SIB 51 32 24

## DELIVERY STOP: REAR BUMPER BRACKET

This Service Information Bulletin (Revision 1) replaces SI **B41 08 24** dated **November 2024**.

**Note:** The yellow highlighted component in the illustration is the right rear mounting bracket.

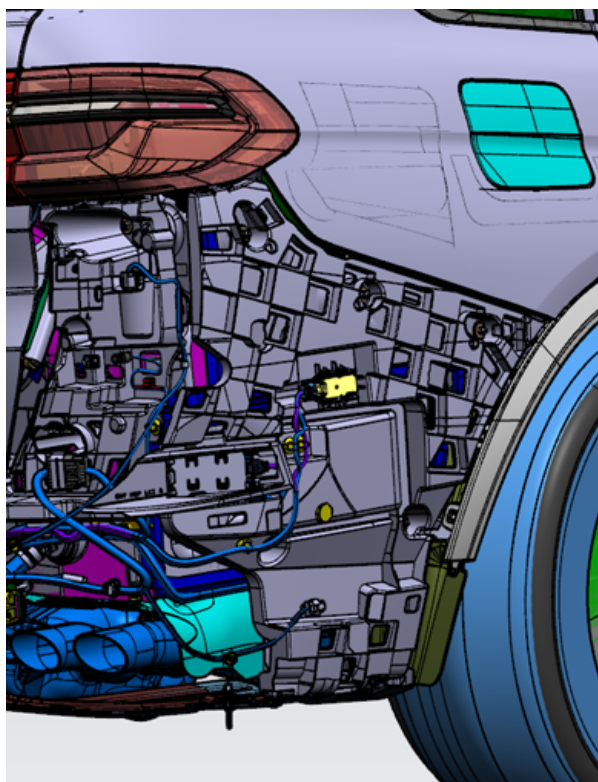
Replace the right rear mounting bracket.

Replace the right rear bumper bracket following the repair instructions listed in ISTA/AIR 51 12 160.

Part Number	Description	Quantity
51 12 8 084 142	Mount, bumper rear right	1

**Note:** The yellow highlighted component in the photo is the short-range radar sensor (SRR sensor).

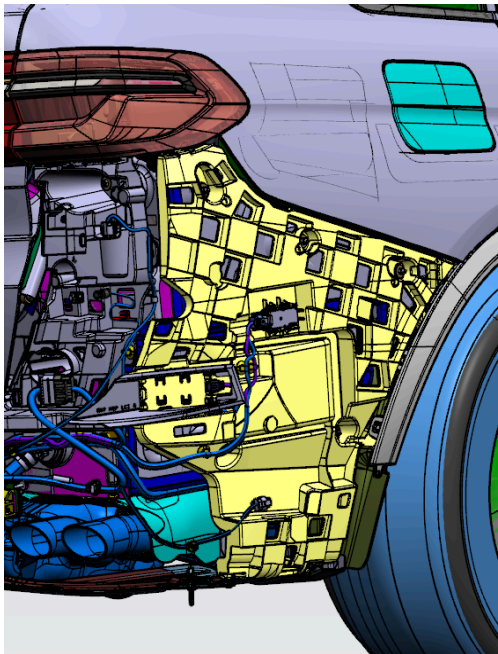
Vehicles produced on October 14, 2024, with option code(s) 05AS (Active Driving Assistant) and/or 5AU (Driving Assistance Pro); and have a short-range radar sensor (SRR sensor) clipped into the left and right rear of the vehicle. The short-range radar sensor (SRR sensor) on the right rear of the vehicle may come loose while driving.

A loose short-range sensor (SRR sensor) may cause a fault in the driver assistance system which is displayed to the customer via a check control message (CCM). In individual cases, the performance of this driver assistance function maybe reduced/not functioning if the vehicle is being approached from the right rear.
